## **Project and Environmental Review Report**

PER No. 13-123

New Grain Transloading Facility and  
Silos

*Date: October 2, 2015*

*Map showing recommended height guidelines for areas in the EVPL Area Plan. From East Vancouver Port Lands Area Plan, May, 2007, Figure 8.*

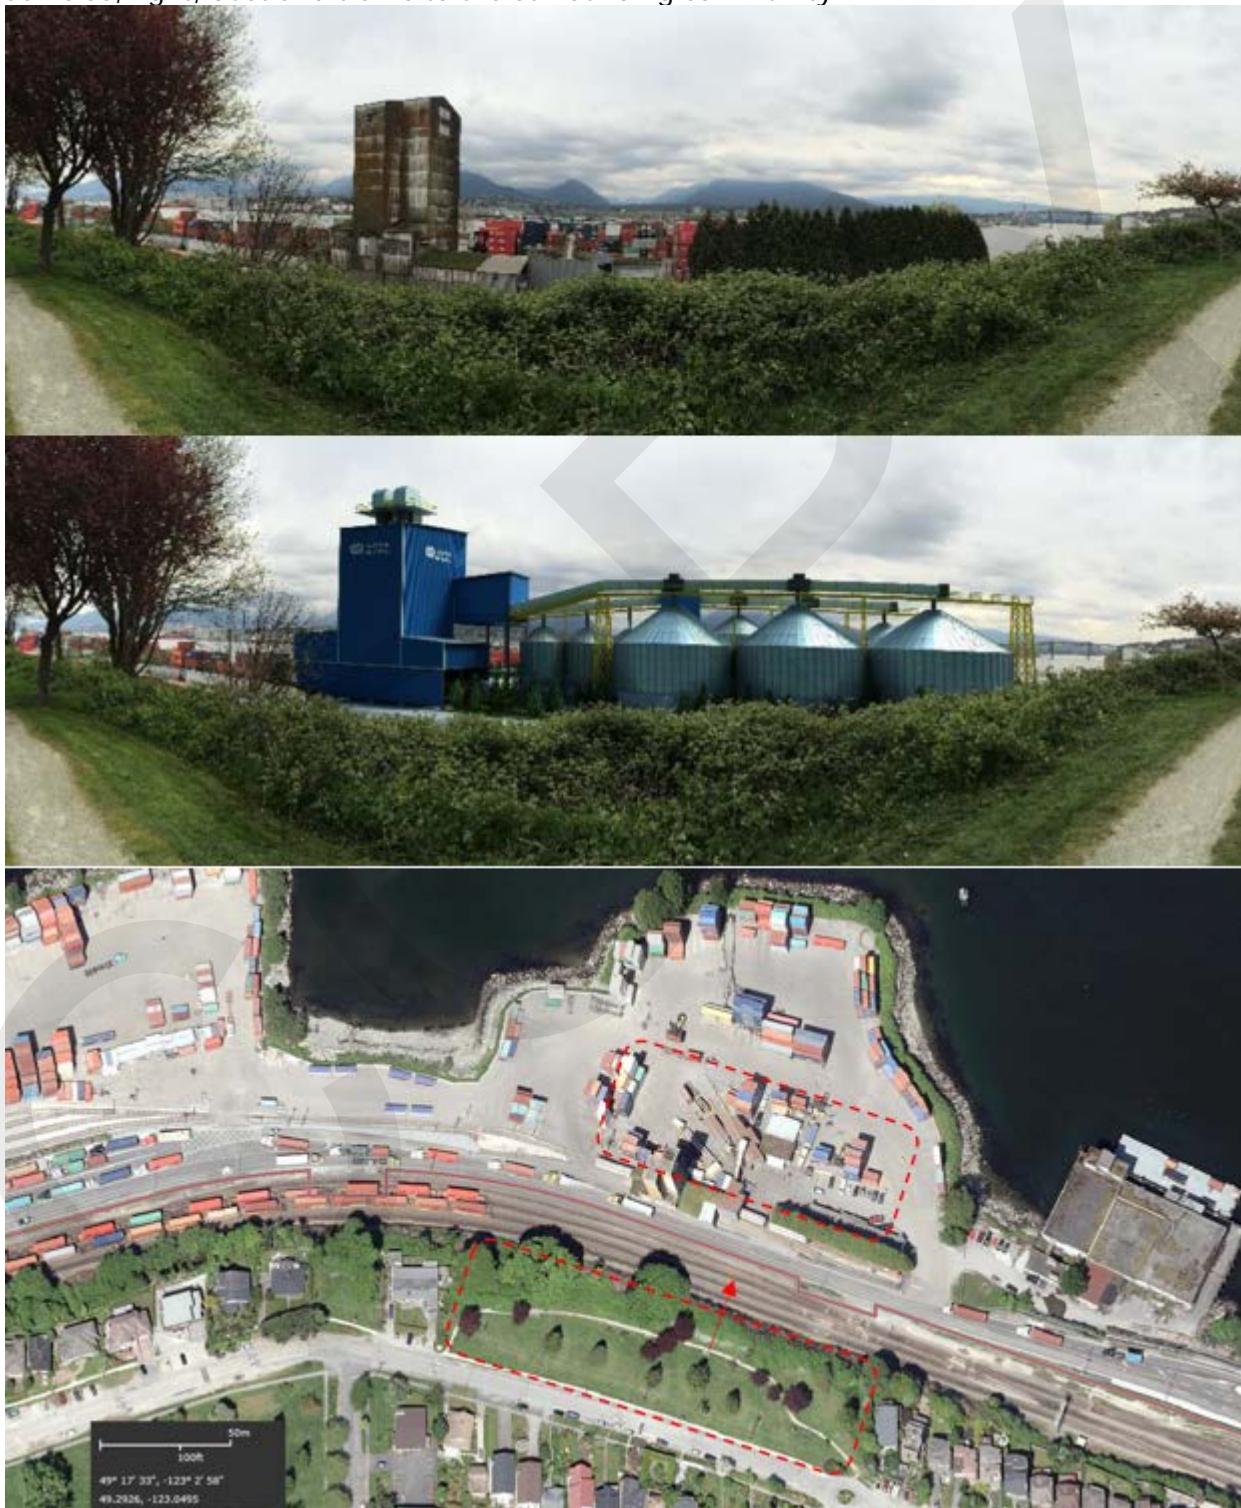
The proposed works in Area 3 are primarily rail track realignment and extension works, and ongoing operational activities that include container loading, unloading, and stacking. Area 3 has a recommended height guideline of 16.8 m (55 ft.) All of these proposed works and existing container operations are under the recommended height guideline of 16.8 m (55 ft.).

The proposed works in Area 4 include the new transloading facility, which consists of the new grain elevator, railcar dumper building, dust management system, and transfer towers and storage silos (with associated conveyor systems). Area 4 has a recommended height guideline of 13.7 m (45 ft.).

<b>Policy No. H1</b>	<i>Heights for new structures within the VFPA portion of the EVPL will generally be between 10.7 metres (35 feet) and 16.7 metres (55 feet) as shown in Figure 8.</i>
Considerations	<ul style="list-style-type: none"> <li>The proposed works and structures for Area 3 meet the recommended height guideline of 16.7 m (55 ft.). The proposed works and structures in Area 4 are over the recommended height guideline of 13.7 m (45 ft.).</li> <li>The EVPL Area Plan provides recommendations to guide developments to minimize view impacts to the surrounding community. The Plan also recognizes that future developments may occur in the area, specifically in vacant or underutilized sites, which will likely impact public and private views from the escarpment.</li> <li>The Applicant's lease area to the west is currently an underutilized site located within a major road and rail corridor. The existing structures are operating past their useful life, and the facility lacks operational and transportation efficiencies. The Applicant's proposed Project seeks to increase site utilization, and modernize and intensify existing uses within a smaller lease footprint. The Applicant has configured the new grain transloading facility to optimize the use of the spatially constrained site, keeping the profile as low as possible while still meeting operational requirements in order to limit the view impacts to the community.</li> </ul>

Skyline Study Elevation View (with 45 ft. guideline height)

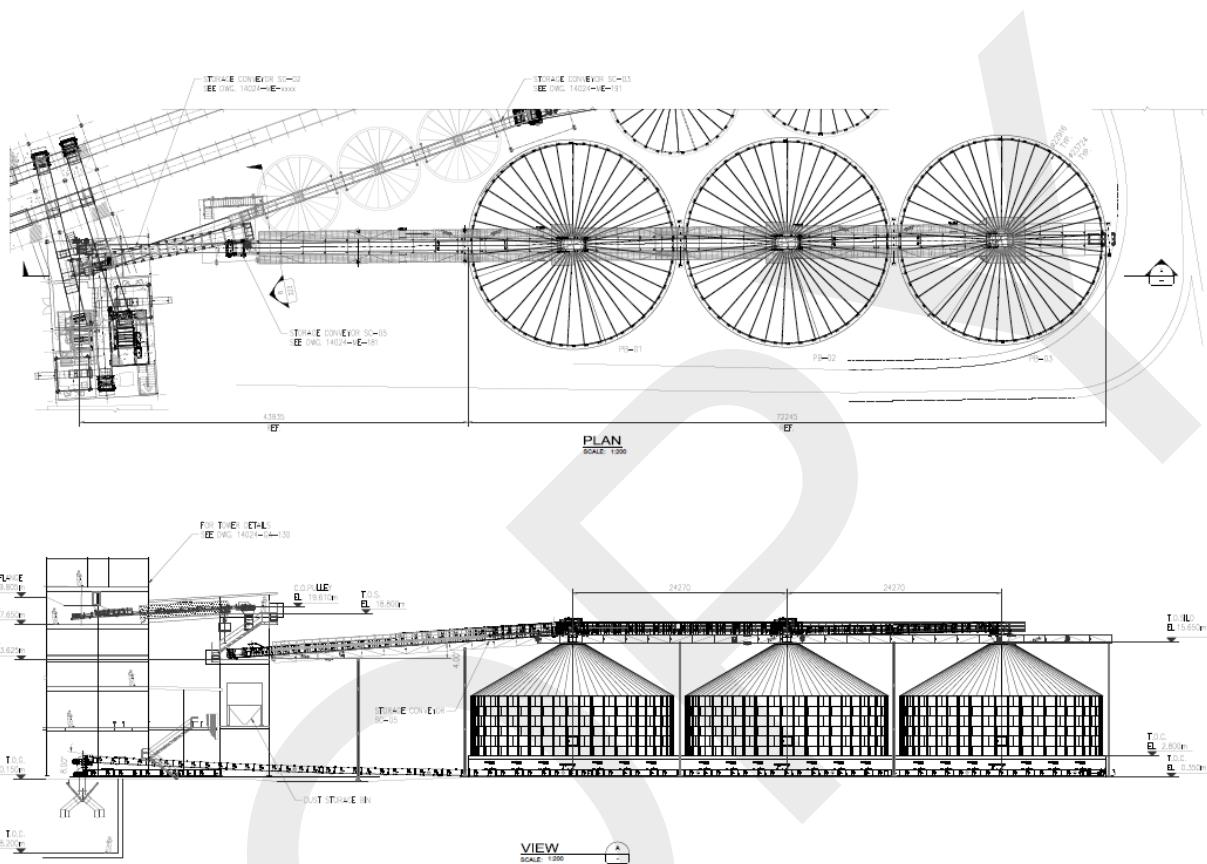
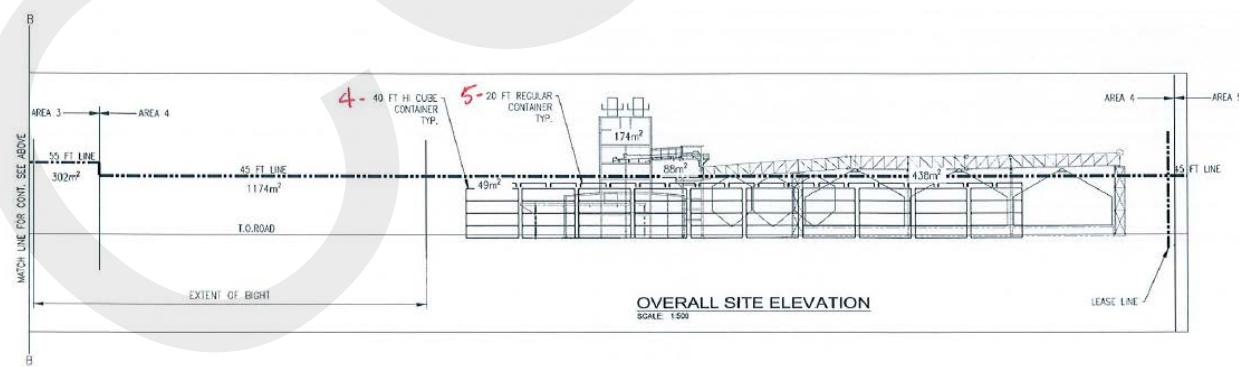
External Referral Comments	VFPA Considerations
<p>The height of the proposed silos and conveyors exceed the recommended heights for Area 4 by at least 15 feet and cites sections from the EVPL Area Plan.</p>	<ul style="list-style-type: none"> <li>• The height of the 2,900 MT storage silos with the overhead conveyor system is approximately 18.38 m (60.3 ft.) which is 4.6 m (15 ft.) above the 13.7 m (45 ft.) recommended height guideline in the Plan.</li> </ul>
<p>If there was any possibility of the silos staying within the 45 ft. height range and if there was a possibility of moving the rail line more to the north to be able to fit in more silos (with a reduced height) on the property.</p>	<ul style="list-style-type: none"> <li>• The Applicant at the meeting and in their <i>Consultation Input Consideration Memo (August, 2015)</i> stated that if the facility was moved to the north, space would be lost to be able to accommodate truck turnarounds and container storage. In particular: <ul style="list-style-type: none"> <li>○ Rail and truck staging length requirements necessitate that the new grain transloading facility and storage silos are located on the west side of the site.</li> <li>○ The new grain elevator is located to minimize view impacts, allow for on-site truck access, and to accommodate the future widening of this section of Commissioner Street. Due to the relocation of the new grain elevator to the north, there was no additional space to locate the new storage silos to the north of the new grain elevator (as was done with the previous storage silos that were demolished in 2008).</li> </ul> </li> </ul>

External Referral Comments	VFPA Considerations
<p>In light of the EVPL Area Plan's policies on the matter of heights in Area 4, this application with silos in excess of 45 feet ought not to be approved.</p>	<ul style="list-style-type: none"> <li>• VFPA is of the opinion that the EVPL Area Plan guidelines anticipate situations, such as the Applicant's proposal, where development of underutilized sites may impact public and private views. The Applicant's proposed Project seeks to increase site utilization, and modernize and intensify existing uses within a smaller lease footprint. The Applicant has configured the new grain transloading facility to optimize the use of the spatially constrained site while trying to limit the view impacts to the community.</li> <li>• The EVPL Area Plan provides recommendations to guide developments to minimize view impacts to the surrounding community. The Plan also recognizes that future developments may occur in the area, specifically in vacant or underutilized sites, which will likely impact public and private views from the escarpment.</li> <li>• In consideration of the Applicant's various studies, assessments and design, VFPA's analysis considered a balance between enabling development while minimizing total impacts from the proposed Project to the surrounding community. VFPA concludes that the Applicant has made best efforts to address the EVPL Area Plan and site the new grain transloading facility to minimize view, noise, dust, and light impacts to the surrounding community.</li> <li>• In recognition of the view impacts to the public park, the Applicant is required to apply mitigation measures to minimize the visual impacts from the park. The Applicant will be applying a neutral colour scheme for the facility and applying landscaping along the entire frontage of the site. The Applicant is also required to provide vegetation screening along the entire length of the storage silos in order to minimize the visual impact of the facility on the community. The Applicant has also committed to exploring a public art project on the storage silos and providing a community amenity contribution to off-set the view impacts to the park. These are conditions No. 10, 11, 22, 23 and 24 in the project permit.</li> </ul>
